## Upgrade Kit Available

The 13" disc in this 05-053 Clutch Kit is the original design part that incorporates an idle stage damper for noise reduction. This dampening feature is also part of a system that causes the clutch disc to break if torque loads exceed a pre-set limit. This design feature is similar to a fuseable link in an electrical system.

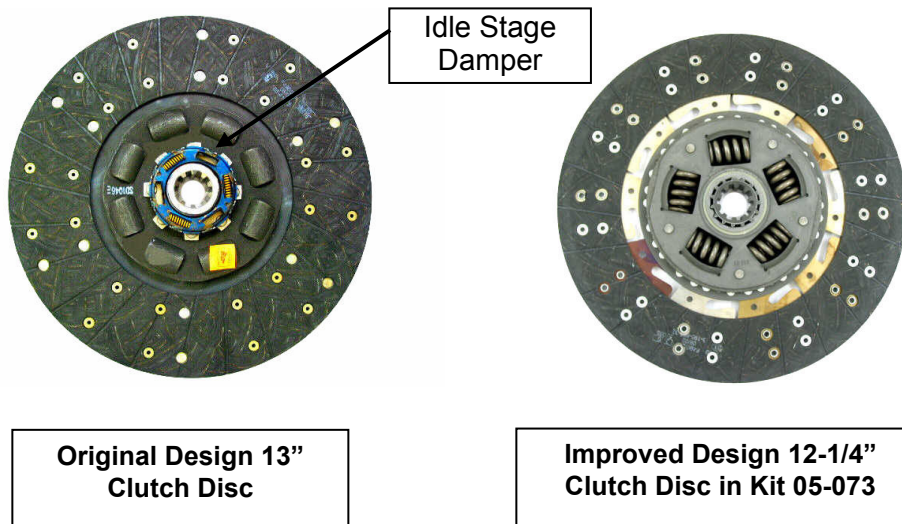
An improved design for the Dodge diesel trucks was introduced in 1994 and features a 12-1/4" clutch disc. While the disc has a slightly smaller OD (12-1/4" versus 13"), the pressure plate has 15% more clamping load. Furthermore, the clutch disc is an improved design, which has good idle control but does not have the torque limiting feature of the Original Design.

We strongly recommend upgrading to the kit number 05-073 and offering your customers improved clutch life and value.
